ROBERT STEVENS ASSOCIATES ARCHITECTURE & PLANNING 200 N. 25th St., Suite 1111 Fresno, CA 93703 (559) 232-1111 www.rsassoc.com	C4854 CDPI, #443 A-12 of sheets
---	--	--

Selland Arena - Auditorium
 700 M Street, Fresno

Selland Arena (SA)

Selland Dressing Rooms

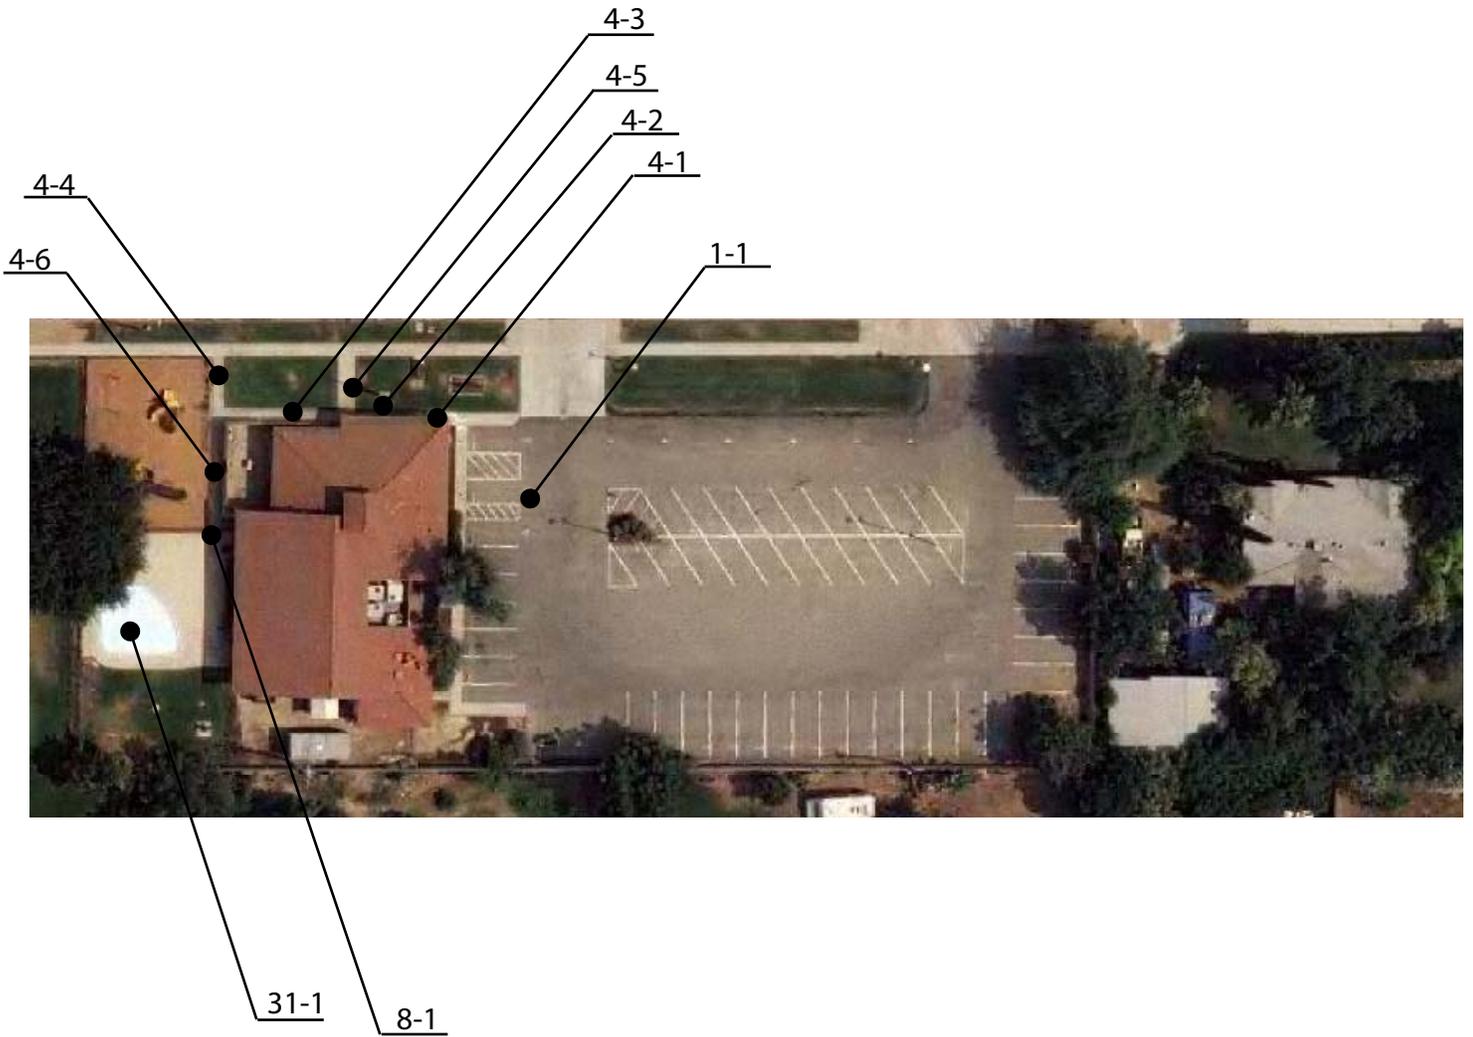
Floor Arena		
4 - 1	Walk	Priority:2
Replace or reorient grate		\$2,000
Notes: Grating is 2.5" x 1.5" (1/2" max) in width.		
State: 1124B.4, 1133B.7.2		
Federal: 4.5.4		
7 - 1	Hazard	Priority:2
Remove overhanging or protruding objects		\$100
Notes: Locker shelf protrudes 18" (4" max) and is 60" (not between 27" to 80") AFF.		
State: 1133B.8.6.1		
Federal: 4.4.1		
7 - 2	Hazard	Priority:2
Remove overhanging or protruding objects		\$100
Notes: Locker shelf protrudes 18" (4" max) and is 60" (not between 27" to 80") AFF.		
State: 1133B.8.6.1		
Federal: 4.4.1		
8 - 1	Door/Gate	Priority:2
Increase or provide maneuvering or clear floor area		\$2,500
Notes: Slope on the swing-side of the door is 9.3% (2% max).		
State: 1133B.2, 1133B.2.4.2, 1133B.7.5		
Federal: 4.13.6		
Provide additional strike edge clearance		\$3,000
Notes: The plane of the doorway is offset 9" (8" max).		
State: 1133B.2.5.3		
Federal: -

Floor Arena		
8 - 2	Door/Gate	Priority:2
Install or modify permanent room signs		\$250
Notes: There is an exit sign but Braille is not provided.		
State: 1011.3 #3		
Federal: -		
Provide additional strike edge clearance		\$3,000
Notes: The plane of the doorway is offset 11" (8" max).		
State: 1133B.2.5.3		
Federal: -		
Replace or adjust door hardware		\$300
Notes: Door hardware requires grasping and twisting. Door hardware is centered 46" (30" to 44") AFF.		
State: 1133B.2.5.2		
Federal: 4.13.9		
8 - 3	Door/Gate	Priority:2
Install or modify permanent room signs		\$250
Notes: There is an exit sign but Braille is not provided.		
State: 1011.3 #3		
Federal: -		
8 - 4	Door/Gate	Priority:2
Enlarge door opening		\$3,500
Notes: Width of clear opening is 27" (32" min).		
State: 1133B.2.2, 1133B.2.3		
Federal: 4.13.5		
Replace or adjust door hardware		\$300
Notes: Doorknob requires grasping and twisting.		
State: 1133B.2.5.2

Floor Arena	
19 - 1 Multiple User Restroom	Priority:2
Install sign	\$250
Notes: California required signage not provided on the door.	
State: 1115B.6	
Federal: 4.30.4	
Install sign	\$250
Notes: Federal required signage not provided on the latch side of the door. ISA not provided.	
State: 1115B.6, 1117B.5.1 #1, 1117B.5.5 #3, 1117B.5.8.1.2	
Federal: 4.30.4	
Increase or provide maneuvering or clear floor area	\$2,500
Notes: 60" min. turning area is not provided in the toilet room.	
State: 1115B.3.1 #1	
Federal: 4.23.3	
Replace or reposition dispensers or mirrors	\$200
Notes: Mirror is mounted so bottom of reflecting surface is 45" (40" max) AFF.	
State: 1115B.8.1	
Federal: 4.19.6	
Insulate water lines	\$100
Notes: Hot water pipe is not insulated.	
State: 1115B.4.3 #4	
Federal: 4.19.4	
Reposition controls and outlets	\$250
Notes: The center of the grip of light switch is 52" (48" max.) AFF.	
State: 1117B.6 #5	
Federal: -

Floor Arena	
25 - 2	Kitchen Priority:2
Provide an accessible counter	\$4,000
Notes: Sink countertop is 35.5" (34" max) AFF. Base cabinet directly under the sink is not designed for repositioning or are removable to provide clearance for wheelchair.	
State: 1115B.4.7 #1	
Federal: 1115B.4.7 #1	
25 - 3	Kitchen Priority:2
Provide an accessible counter	\$4,000
Notes: Base cabinet directly under the sink is not designed for repositioning or are removable to provide clearance for wheelchair.	
State: 1115B.4.7 #1	
Federal: -

Sunset Neighborhood Center - First Floor
 1345 West Eden, Fresno

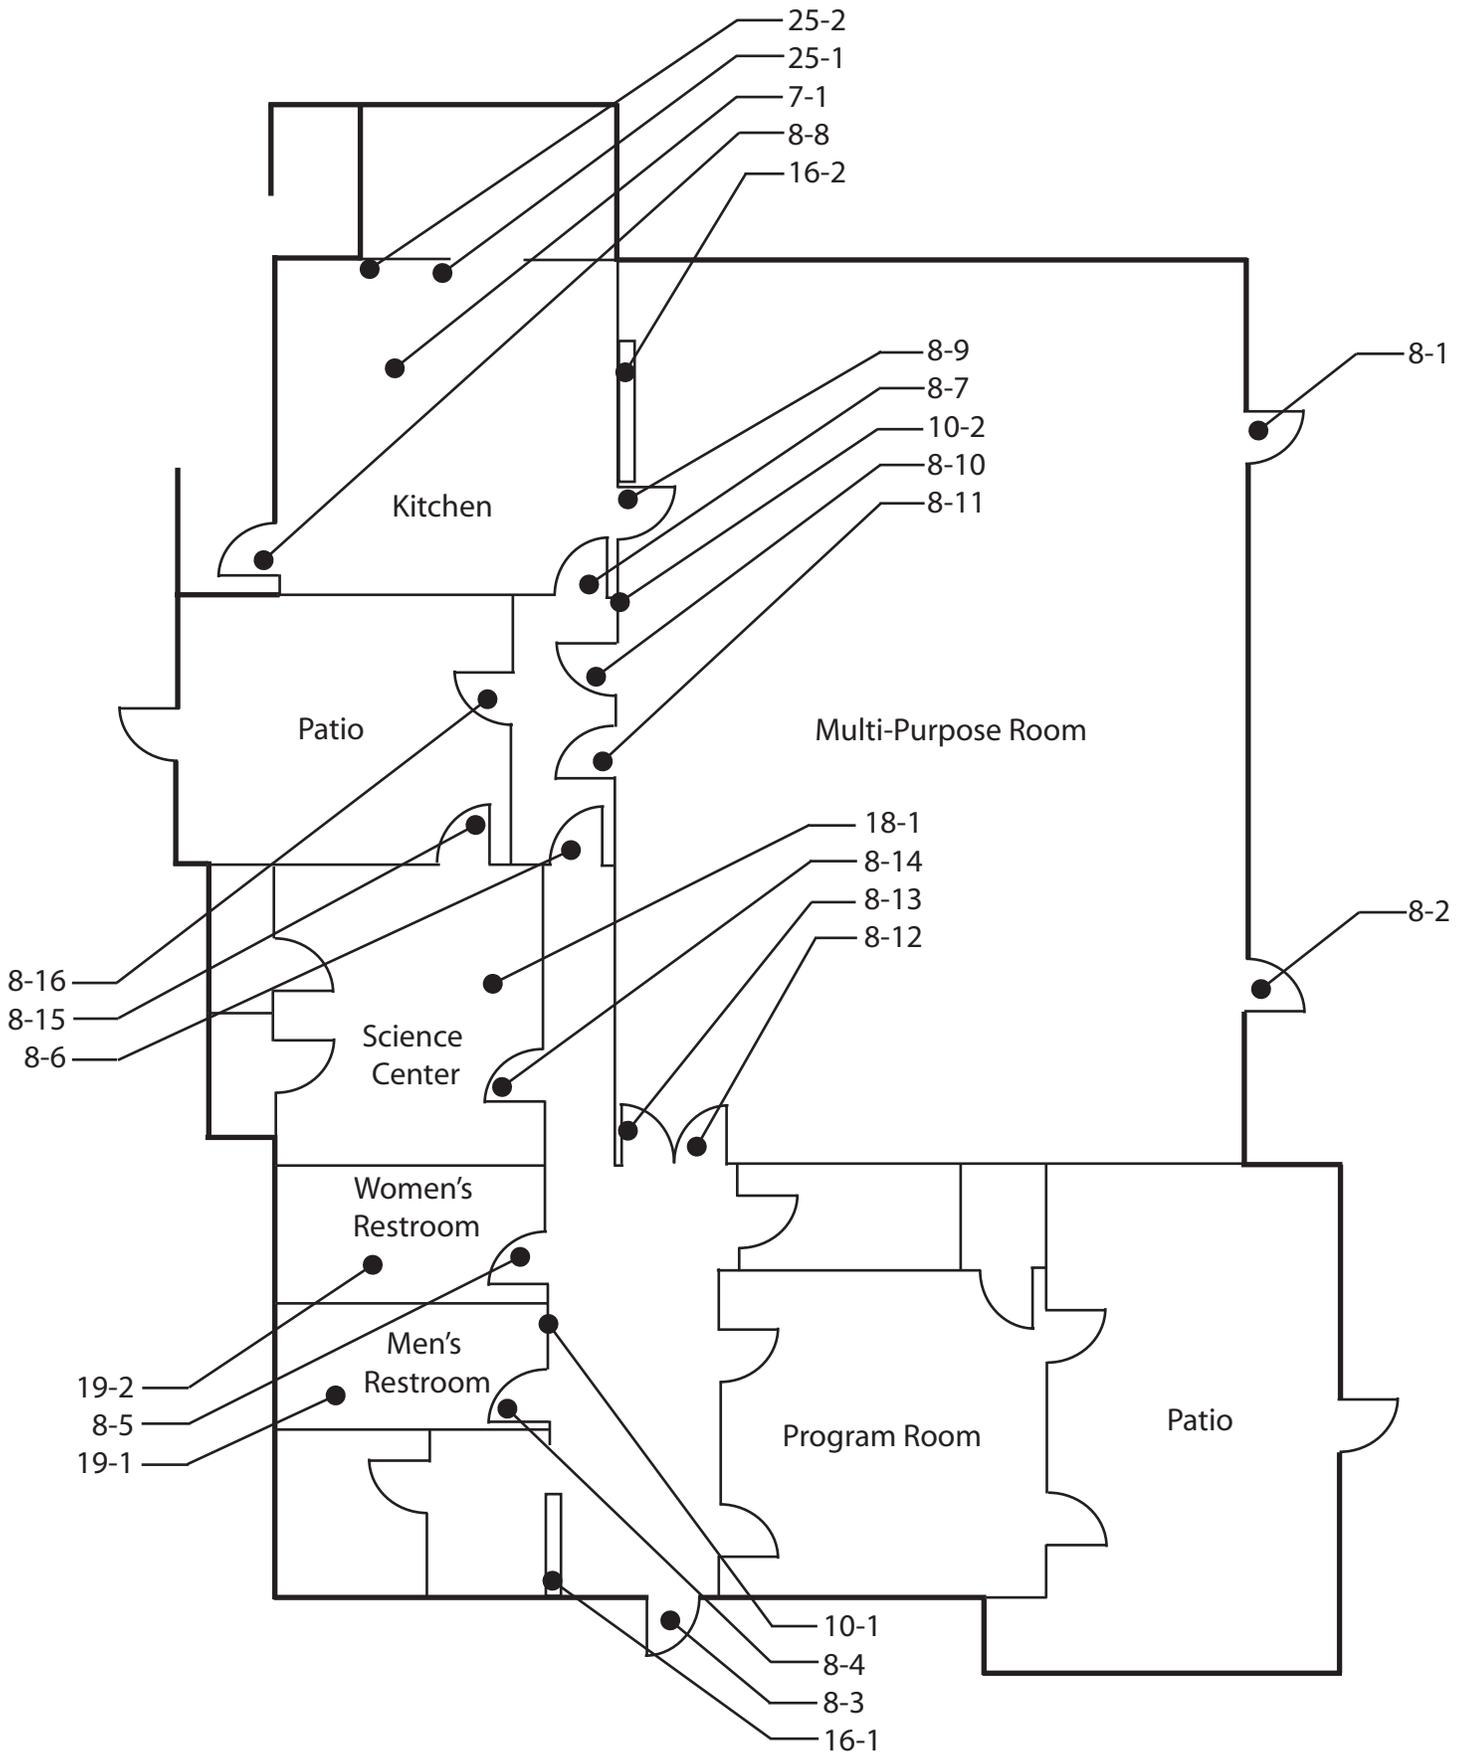
Floor 1		
7 - 1	Hazard	Priority: 4
Remove overhanging or protruding objects		\$100
Notes: Hood in the kitchen is 76-7/8" (80" min) high.		
State: 1133B.8.2, 1133B.8.6.2		
Federal: 4.4.2		
8 - 1	Door/Gate	Priority: 2
Replace or modify door threshold		\$300
Notes: Threshold is 3/4" (1/2" max) high.		
State: 1133B.2.4.1		
Federal: 4.13.8		
Enlarge door opening		\$3,500
Notes: Height of clear opening is 78" (80" min) due to door closer.		
State: 1008.11, 1133B.2.2		
Federal: 4.4.2		
Adjust door closer		\$100
Notes: Operating effort is 12 lbs (5 lbs max). Unsure if it is a fire door.		
State: 1133B.2.5		
Federal: 4.13.11		
Increase or provide maneuvering or clear floor area		\$2,500
Notes: Slope on the swing-side of door is 4.6% (2% max).		
State: 1133B.2, 1133B.2.4.2, 1133B.7.5		
Federal: 4.13.6		
Provide additional strike edge clearance		\$3,000
Notes: Strike-edge clearance on swing-side is 13-1/2" (24" min) for exterior doors.

Floor 1	
8 - 2	Door/Gate
	Priority:2
Replace or modify door threshold	\$300
Notes: Threshold is 3/4" (1/2" max) high.	
State: 1133B.2.4.1	
Federal: 4.13.8	
Enlarge door opening	\$3,500
Notes: Height of clear opening is 77" (80" min) due to door closer.	
State: 1008.11, 1133B.2.2	
Federal: 4.4.2	
Adjust door closer	\$100
Notes: Operating effort is 8 lbs (5 lbs max).	
State: 1133B.2.5	
Federal: 4.13.11	
Increase or provide maneuvering or clear floor area	\$2,500
Notes: Slope on the swing-side of door is 4.7% (2% max).	
State: 1133B.2, 1133B.2.4.2, 1133B.7.5	
Federal: 4.13.6	
Provide additional strike edge clearance	\$3,000
Notes: Strike-edge clearance on swing-side is 13-1/2" (24" min) for exterior doors.	
State: 1133B.2.4.3	
Federal: 4.13.6	
Install or modify permanent room signs	\$250
Notes: There is an exit sign but Braille is not provided.	
State: -	
Federal: 1117B.5.7, 4.30.6

Floor 1	
25 - 1 Kitchen	Priority:2
Modify lavatory/counter clearances	\$3,500
Notes: Clear space beneath the sink is 23-1/2" (29" min) high. Sink is 11-1/4" (6-1/2" max) deep. Sink countertop is 36-5/8" (34" max) AFF.	
State: 1115B.4.7 #1	
Federal: 4.24.2, 4.24.3, 4.24.4	
Insulate water lines	\$100
Notes: Drain pipes are not insulated.	
State: 1115B.4.7 #1	
Federal: 4.24.6	
Replace or reposition dispensers or mirrors	\$250
Notes: Soap dispenser is 50-1/2" (40" max)AFF.	
State: 1115B.9.2	
Federal: 4.23.7	
25 - 2 Kitchen	
	Priority:4
Modify lavatory/counter clearances	\$3,500
Notes: Clear space beneath the sink is 17-1/2" (19" min) deep. Sink is 7" (6-1/2" max) deep.	
State: 1115B.4.7 #1	
Federal: 4.24.3, 4.24.4	
Insulate water lines	\$100
Notes: Drain pipes are not insulated.	
State: 1115B.4.7 #1	
Federal: 4.24.6	
Replace or reposition dispensers or mirrors	\$300
Notes: Soap dispenser is 46" (40" max)AFF. Towel dispenser is 65" (40" max) AFF.

Ted Willis Community Center - First Floor
770 North San Pablo, Fresno

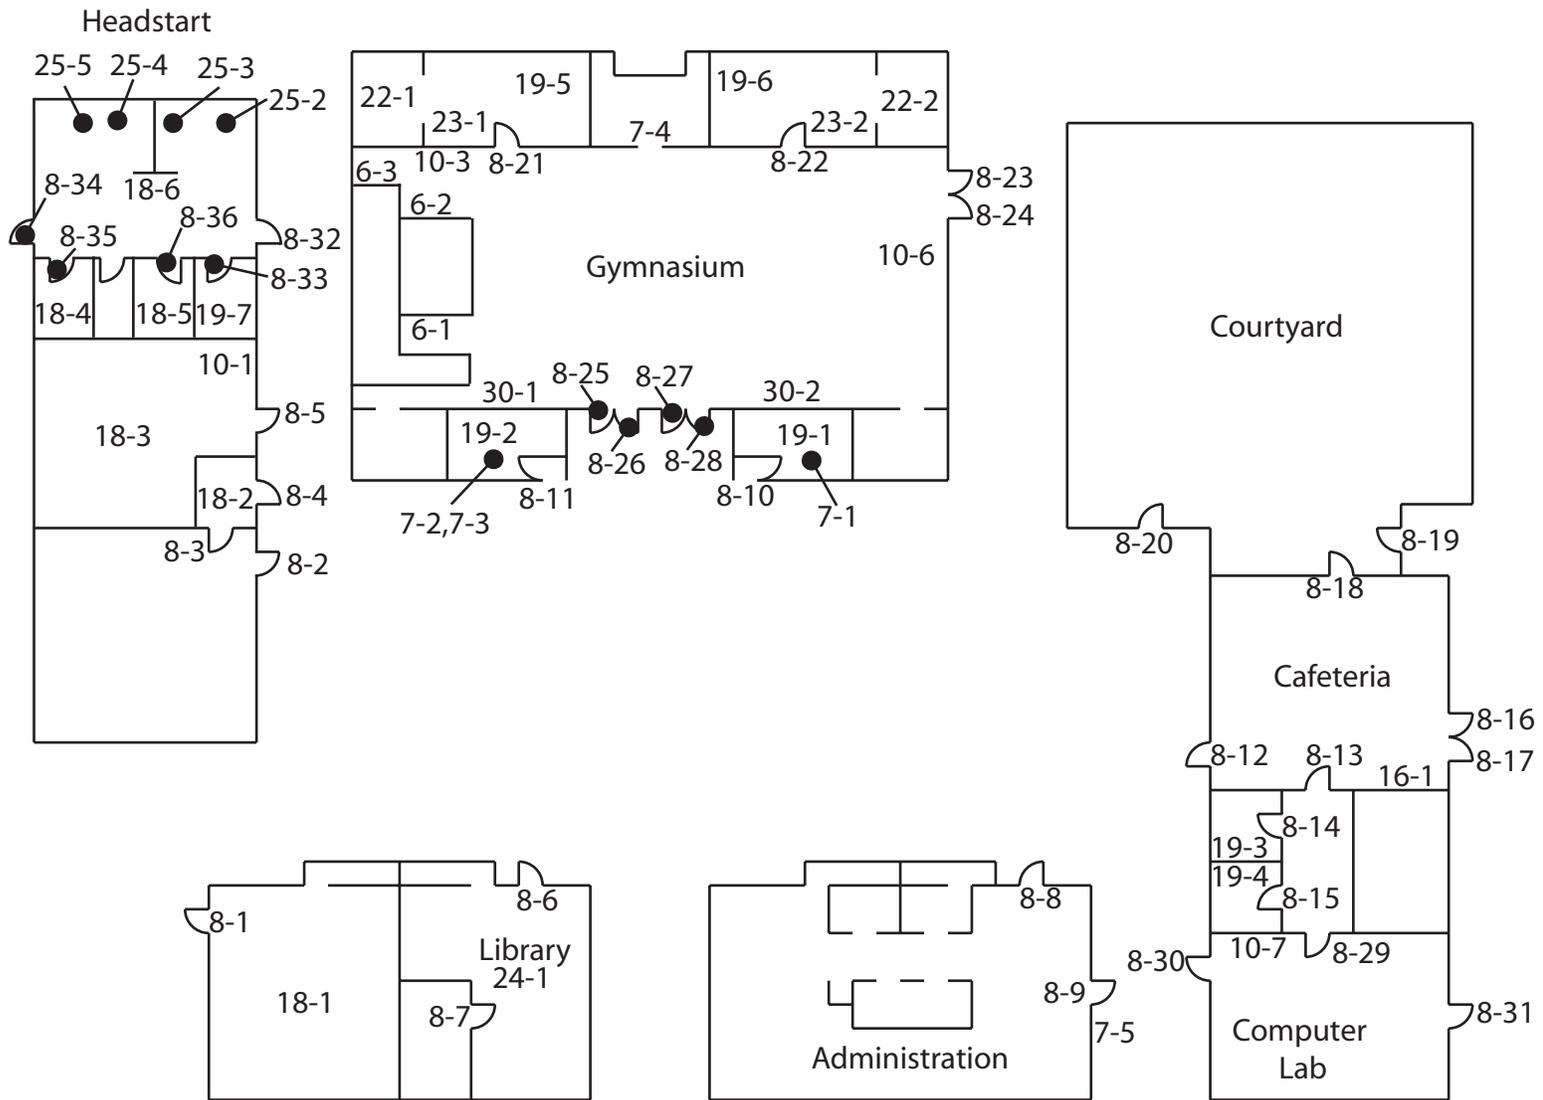
Floor 1	
25 - 4 Kitchen	Priority: 4
Modify lavatory/counter clearances	\$3,500
Notes: Sink is 7" (6-1/2" max) deep.	
State: 1115B.4.7 #1	
Federal: 4.24.4	
Insulate water lines	\$100
Notes: Hot water and drain pipes are not insulated.	
State: 1115B.4.7 #1	
Federal: 4.24.6	
Provide an accessible counter	\$4,000
Notes: Countertop and sink are 36-3/4" (34" max) above the finished floor.	
State: -	
Federal: 1115B.4.7 #1	
25 - 5 Kitchen	Priority: 4
Modify lavatory/counter clearances	\$3,500
Notes: Sink is 7" (6-1/2" max) deep.	
State: 1115B.4.7 #1	
Federal: 4.24.4	
Insulate water lines	\$100
Notes: Hot water and drain pipes are not insulated.	
State: 1115B.4.7 #1	
Federal: 4.24.6	
Provide an accessible counter	\$4,000
Notes: Length of countertop provided for kitchen sink and work surface is 24" (30" min). Base cabinets directly under the sink and work surface counter areas are not designed to provide clearance for a wheelchair.

State: 1115B.4.7 #1	
Federal: -	
30 - 1 Grandstand/Bleacher (interior or exterior)	Priority: C
Provide accessible seating	\$250
Notes: Designated accessible seating is not provided.	
State: 1104B.3.4.1, 1104B.3.5, 1104B.3.6, 1104B.3.8	
Federal: 4.1.3(19)(a), 4.33.3	
30 - 2 Grandstand/Bleacher (interior or exterior)	Priority: C
Provide accessible seating	\$250
Notes: Designated accessible seating is not provided.	
State: 1104B.3.4.1, 1104B.3.5, 1104B.3.6, 1104B.3.8	
Federal: 4.1.3(19)(a), 4.33.3

Valdez Hall - Exterior & First Floor
700 M Street, Fresno

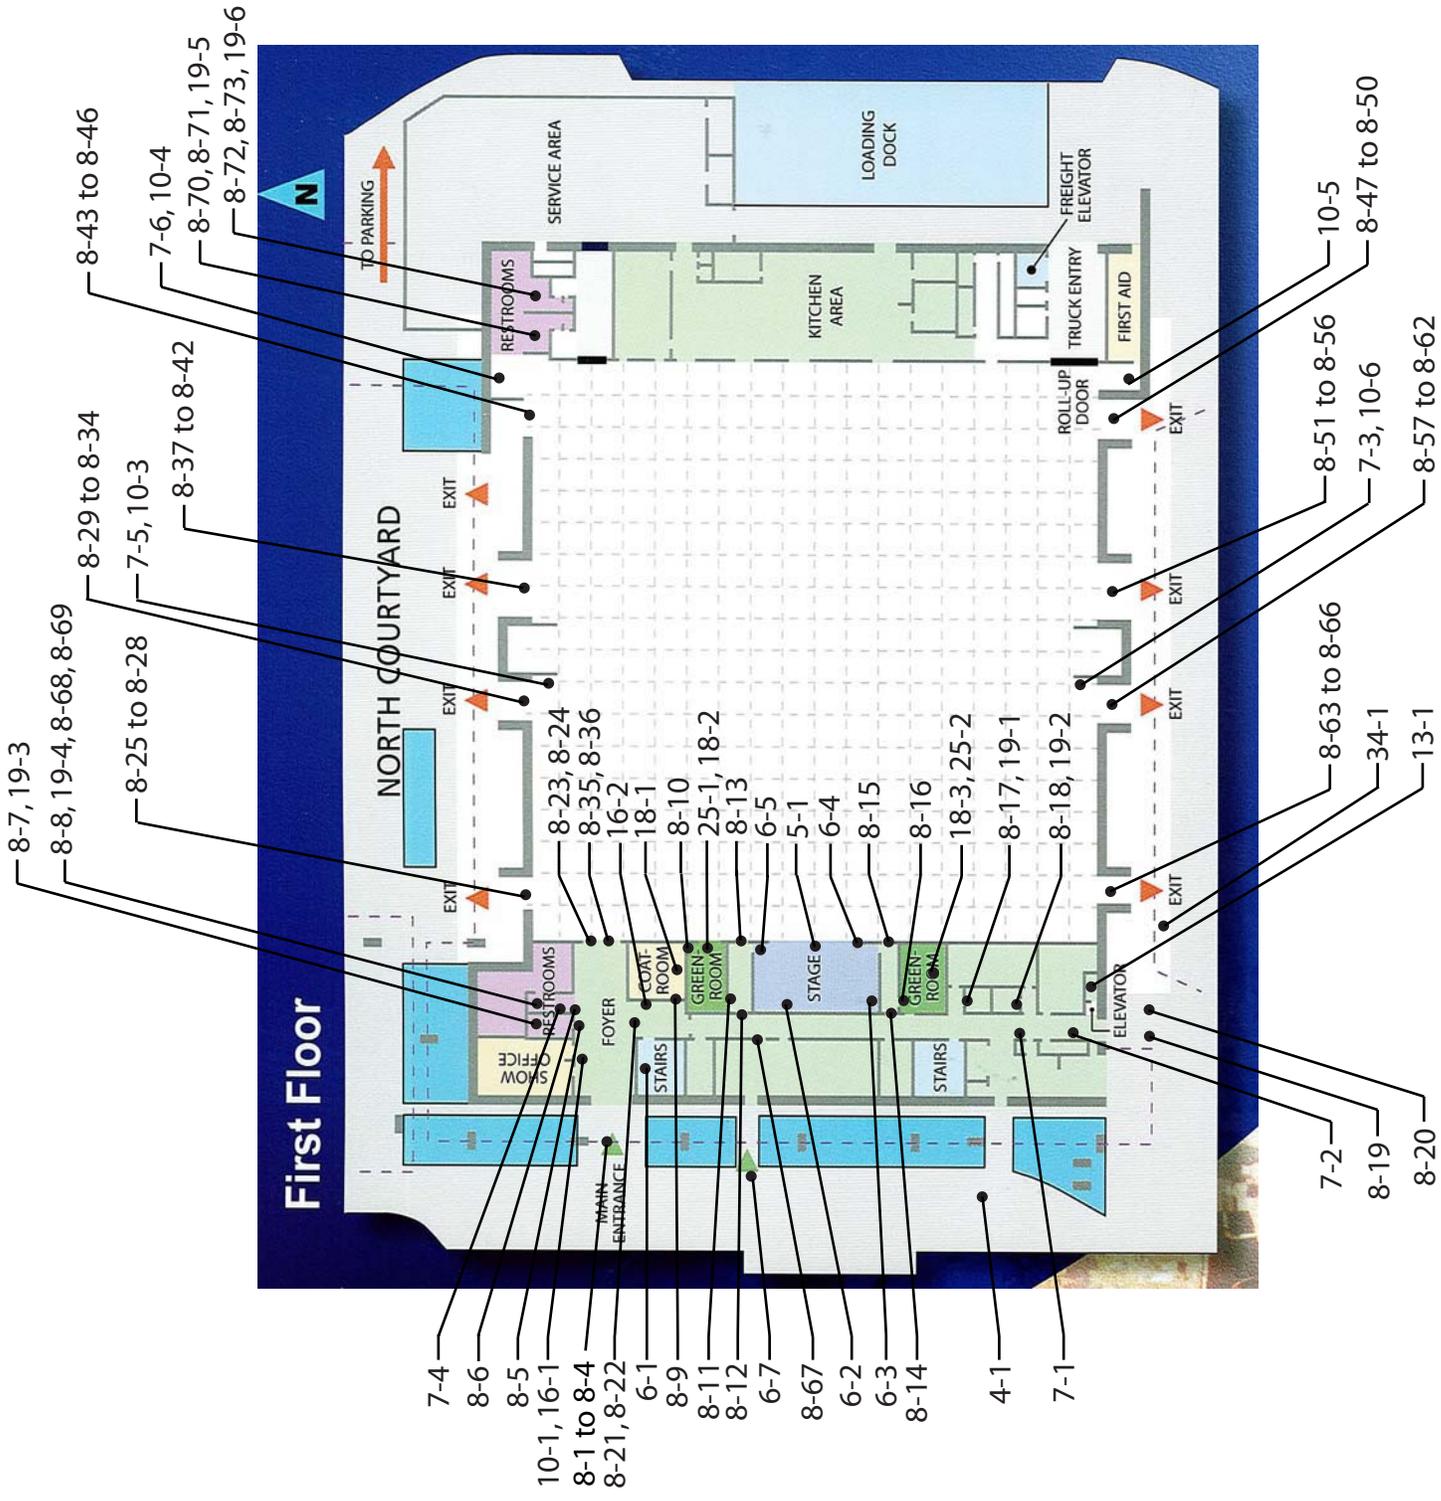
Floor 1	
25 - 1 Kitchen	Priority:2
Provide an accessible counter	\$4,000
Notes: Base cabinets directly under the sink does not provide clearance for a wheelchair. Knee space is not provided.	
State: 1115B.4.7 #1	
Federal: -	
Insulate water lines	\$100
Notes: Hot water pipe is not insulated.	
State: 1115B.4.7 #1	
Federal: 4.24.6	
Replace or reposition dispensers or mirrors	\$500
Notes: Towel dispenser is 52-1/2" (40" max) and soap dispenser is 41" (40" max) above the finished floor.	
State: 1115B.9.2	
Federal: 4.23.7	
25 - 2 Kitchen	Priority:2
Provide an accessible counter	\$4,000
Notes: Base cabinets directly under the sink does not provide clearance for a wheelchair. Knee space is not provided.	
State: 1115B.4.7 #1	
Federal: -	
Replace or reposition dispensers or mirrors	\$500
Notes: Towel dispenser is 53-1/2" (40" max) and soap dispenser is 38" (40" max) above the finished floor.	
State: 1115B.9.2	
Federal: 4.23.7

Modify operating mechanism	\$2,000
Notes: Control requires grasping and twisting.	
State: -	
Federal: 1115B.4.7 #1
